Marketing Bulletin

PRODUCT: X-09™ High Security Lock

BULLETIN NUMBER: MB007

X-09™ Cam Pawl Removal

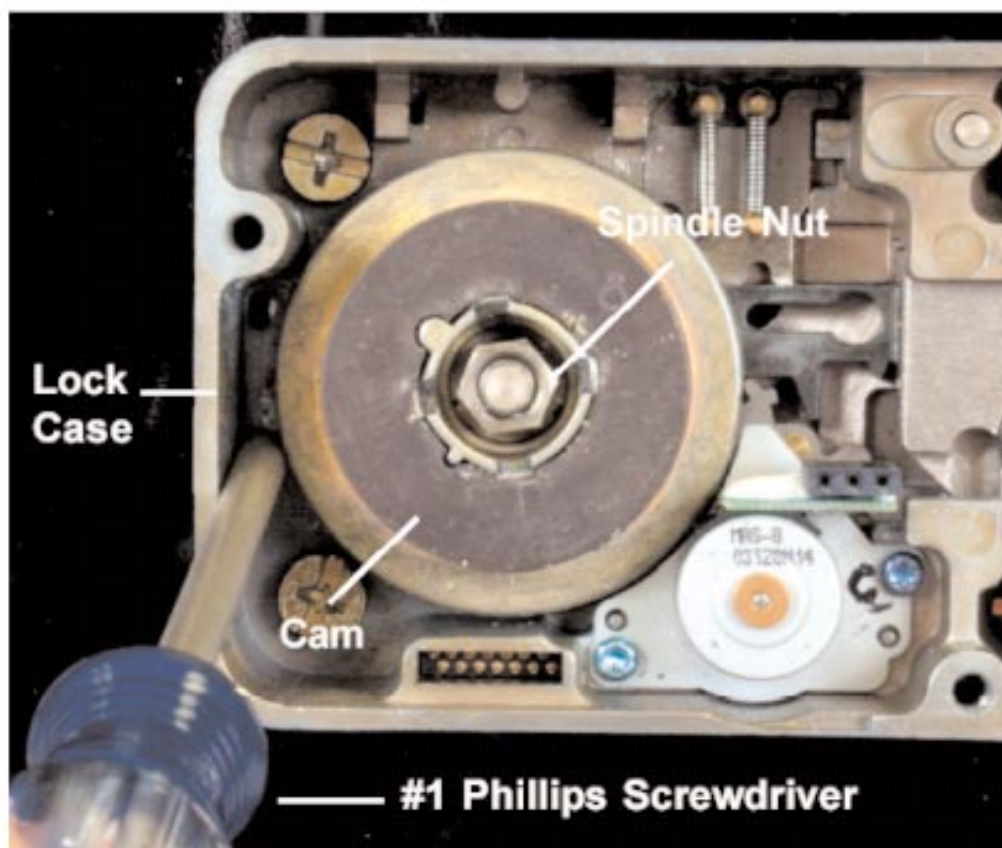
The cam pawl has been removed from the X-09/CDX-09 locks. This change was implemented on 02/12/03 starting with S/N 00X0900102122003ARM.

If it becomes necessary to remove and reinstall the spindle nut during lock installation or maintenance, the drive cam can be secured by **carefully** placing a #1 Phillips screwdriver between the cam and the lock case as shown in the picture below. This procedure replaces the Service Tip found on page 11 of the X-09 Installation Instructions.
